REGIONAL REVIEW FINDING

Submitting Local Government: City of Johns Creek
Name of Proposal: Johns Creek Walk Phase II

Preliminary Report:	March 3, 2009	DEVELOPMENT OF REGIONAL IMPACT REVIEW REPORT	Project:	Johns Creek Walk, Phase II #1999
Final Report Due:	April 2, 2009		Comments Due By:	March 17, 2009

V/C Ratios

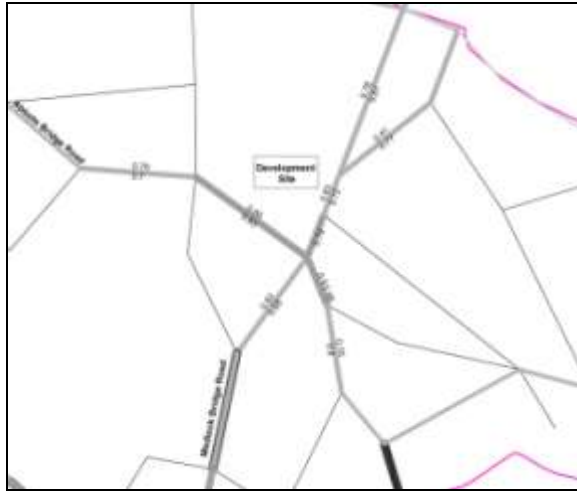
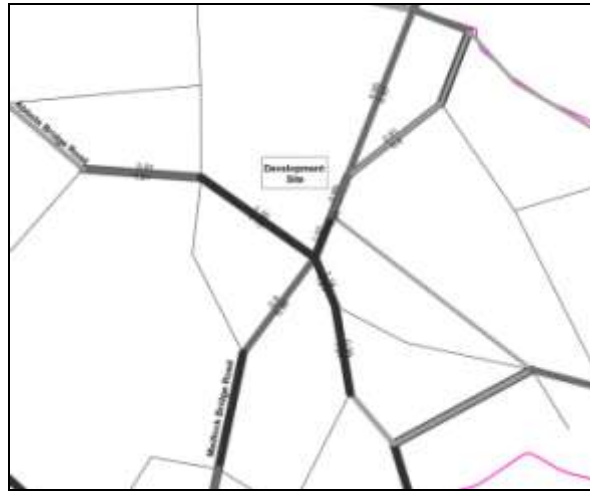
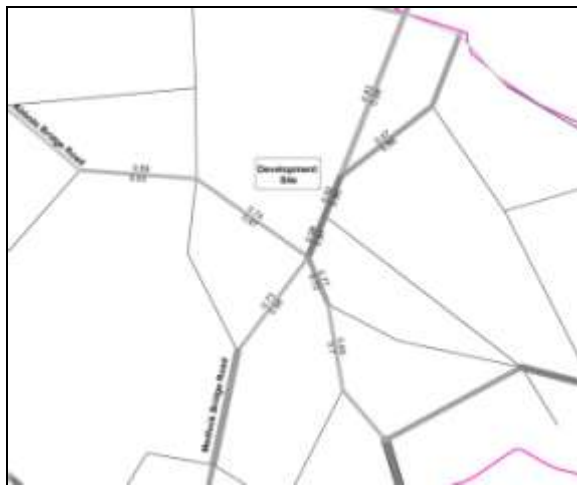
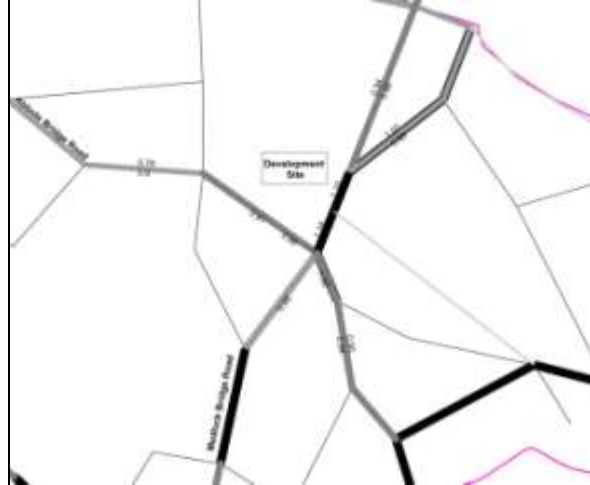
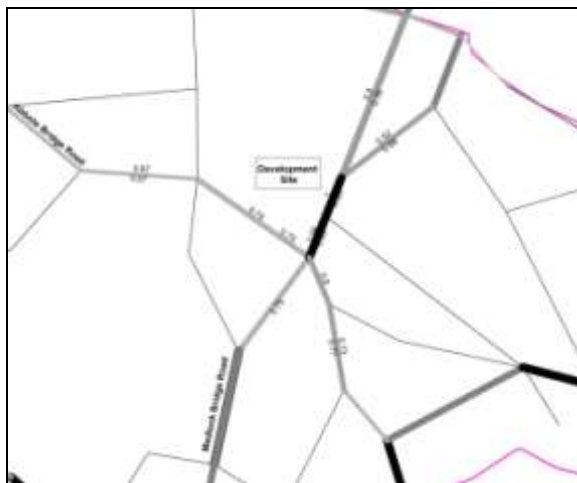
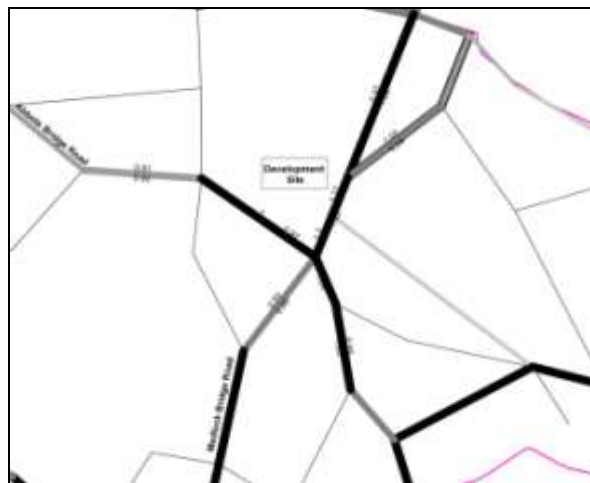
Incorporating the trip generation results, the transportation consultant distributed the traffic on the current roadway network. An assessment of the existing Level of Service (LOS) and projected LOS based on the trip distribution findings helps to determine the study network. The results of this exercise determined the study network, which has been approved by ARC and GRTA. If analysis of an intersection or roadway results in a substandard LOS "D", then the consultant recommends improvements.

Projected traffic volumes from the Regional Travel Demand Model are compared to the assigned capacity of facilities within the study network. This data is used to calculate a volume to capacity (V/C) ratio. The V/C ratio values that define the LOS thresholds vary depending on factors such as the type of terrain traversed and the percent of the road where passing is prohibited. LOS A is free-flow traffic from 0 to 0.3, LOS B is decreased free-flow from 0.31 to 0.5, LOS C is limited mobility from 0.51 to 0.75, LOS D is restricted mobility from 0.76 to 0.9, LOS E is at or near capacity from 0.91 to 1.00, and LOS F is breakdown flow with a V/C ratio of 1.01 or above. As a V/C ratio reaches 0.8, congestion increases. The V/C ratios for traffic in various network years are presented in the following table. Any facilities that have a V/C ratio of 1.0 or above are considered congested.

OVERALL SITE PLAN
JOHNS CREEK WALK PHASE II
LAND LOTS 357, 358, 373, 374 - 1st DISTRICT - 1st SECTION
FULTON COUNTY, GEORGIA

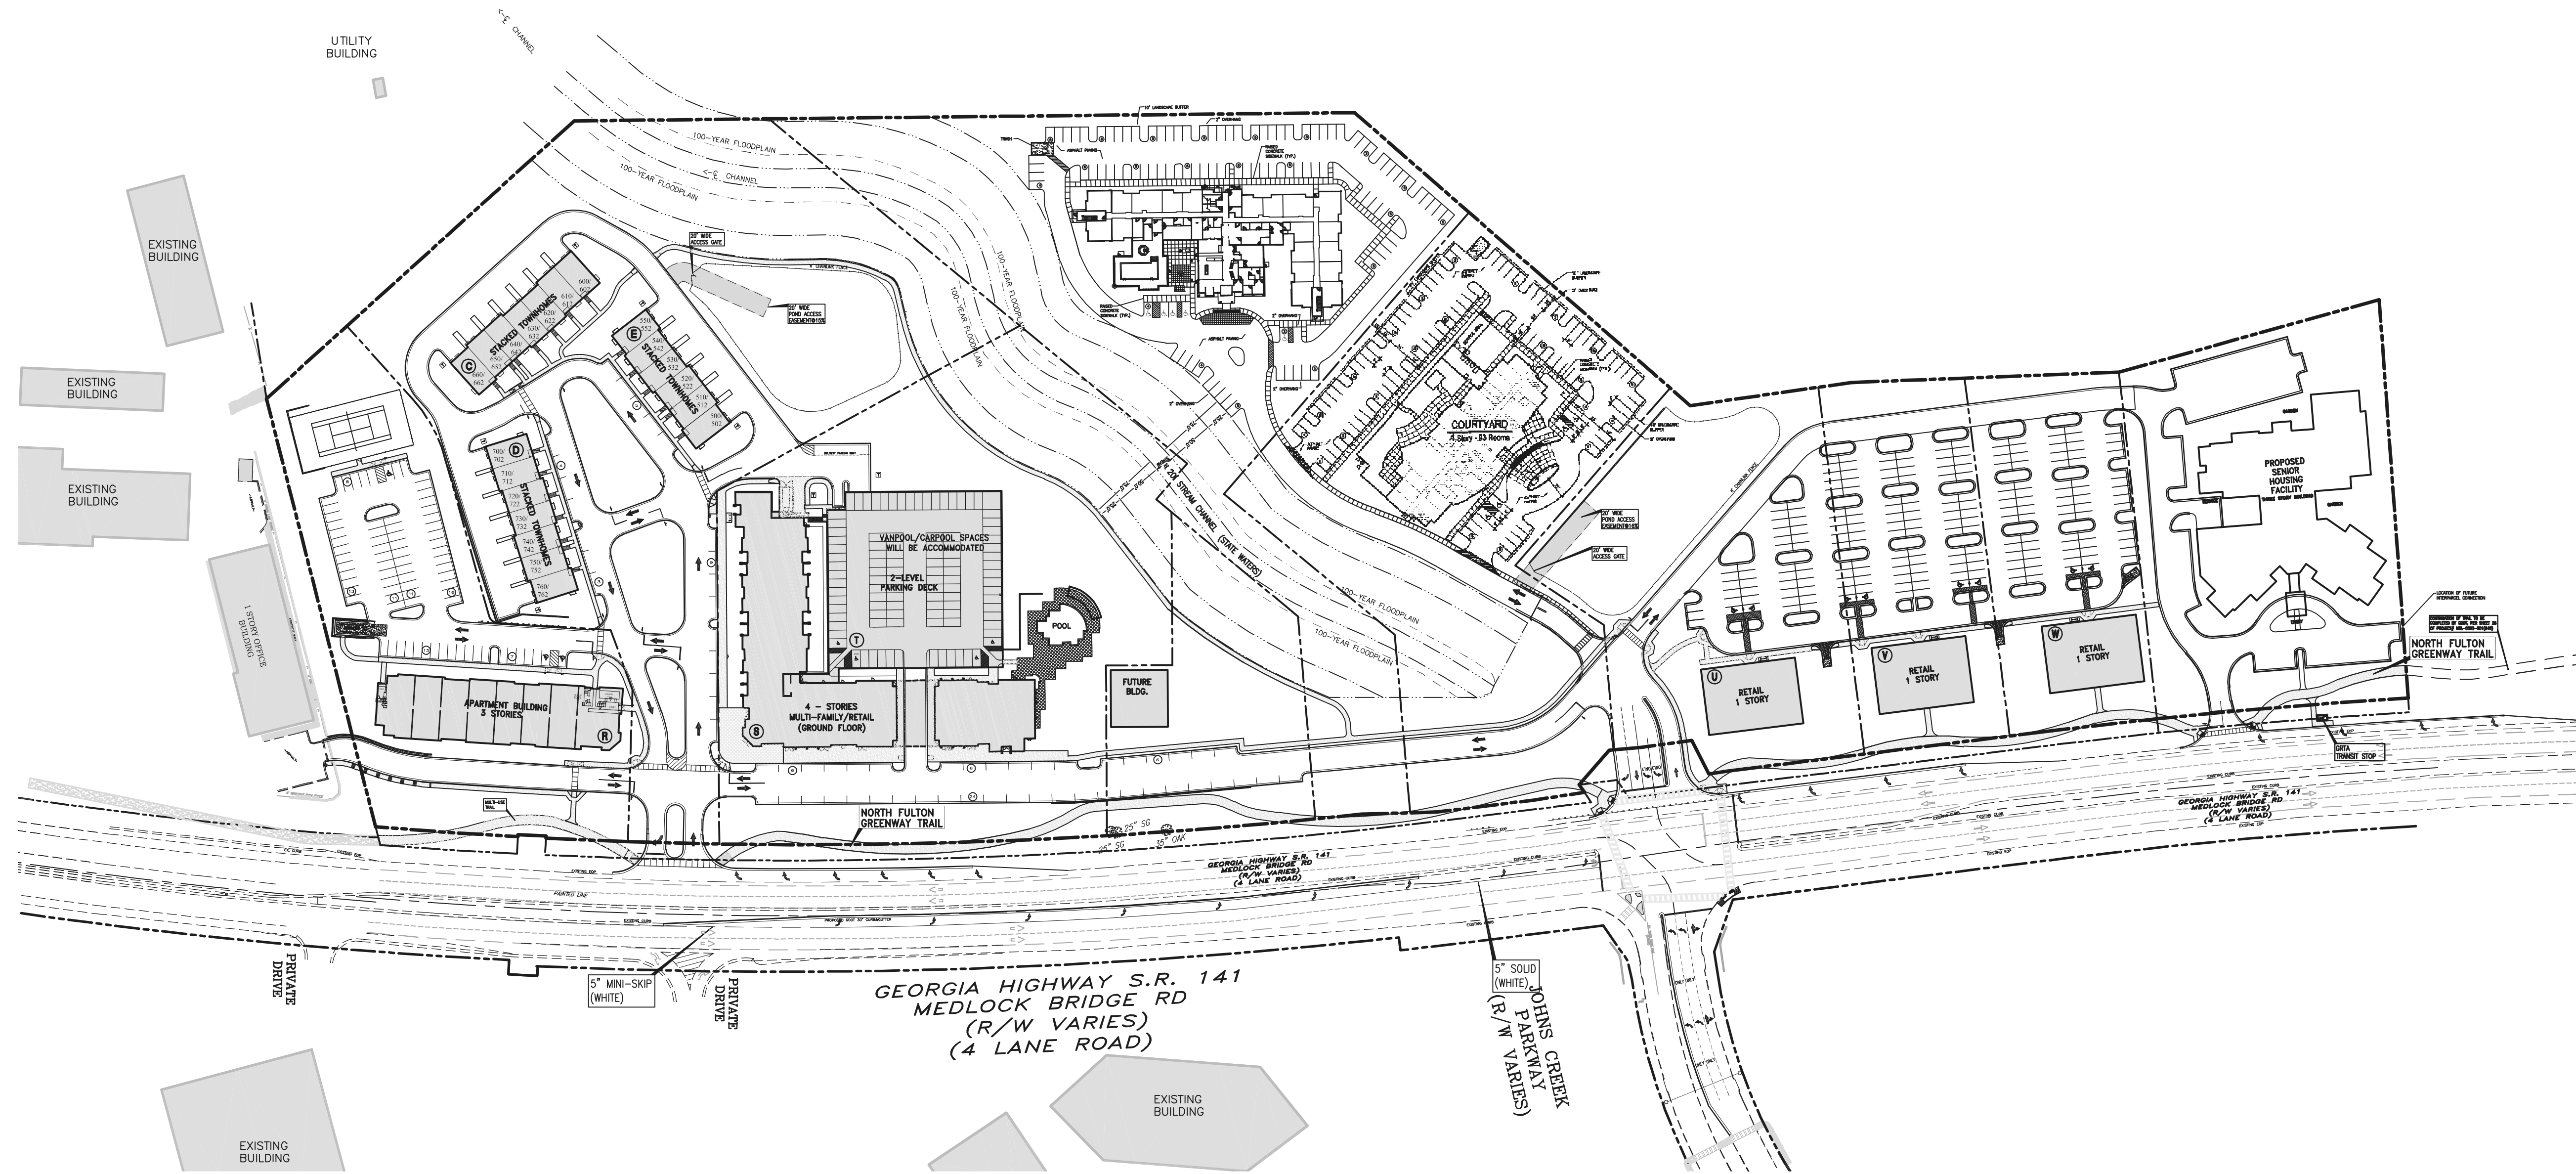
The property is in the Chattahoochee Corridor watershed, but it is not within the Chattahoochee River Corridor. The site plan and the USGS coverage for the area show a tributary to Johns Creek, a Chattahoochee tributary, crossing the property, with an existing impoundment on the site. The stream is subject to the requirements of the City of Johns Creek stream buffer protection ordinance, which requires a 50-foot undisturbed buffer and an additional 25-foot impervious surface setback on most streams. The City's 50-foot buffer and 75-foot setback are clearly shown along the stream shown on the submitted site plan.

All state waters that may be on the property will also be subject to the 25-foot Erosion and Sedimentation buffer requirement. Any intrusion into the State 25-foot Erosion and Sedimentation will require a variance from Georgia EPD.
